Fire Vault and Building Foundation Evaluation Letter

Project Name: Easttown Crossing Apartments (Building B)

PROJECT MEMO

TO: Jason Little, City of Puyallup
FROM: Todd Sawin
Tacoma - (253) 383-2422
DATE: May 7, 2025
PROJECT NO.: 2230752.10
PROJECT NAME: East Town Crossing
SUBJECT: Fire Vaults and Building Footings

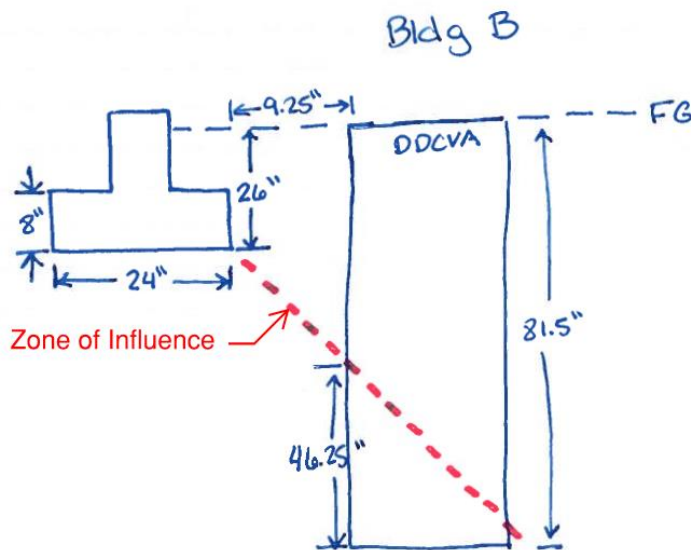
This letter is intended to address the City’s concern on the relationship between the fire vaults and building footings on the East Town Crossing site. In constructed condition, Building B’s fire vault is the closest to the building footing with a separation of 9.25”. This puts the near edge 46.25” into the footings zone of influence. As this is the worst-case condition, this is what has been analyzed. See the sketch below for a depiction.

Based on the size disparity between the vault and the building footing, as well as the fact the building footing is above the vaults zone of influence, the fire vault will not compromise the building footing.

The fire vault is rated for HS-20 loading per the requirements outlined in Note 2 on the Water Vault Detail (C.O.P Std Dtl 03.11.01 attached below). Based on this rating, the vault is able to withstand a 32-kip axle loading. Per the structural calculations, the building imparts a surcharge load of 4,000 pounds per linear foot. As the long edge of the vault is 8 ft, the total surcharge is 32,000 pounds or 32-kips. As a result, the vault is able to withstand the loadings of the footing and structure.

Based on this worst case scenario, by inspection, all other vaults are able to withstand the force of the building and vice versa.
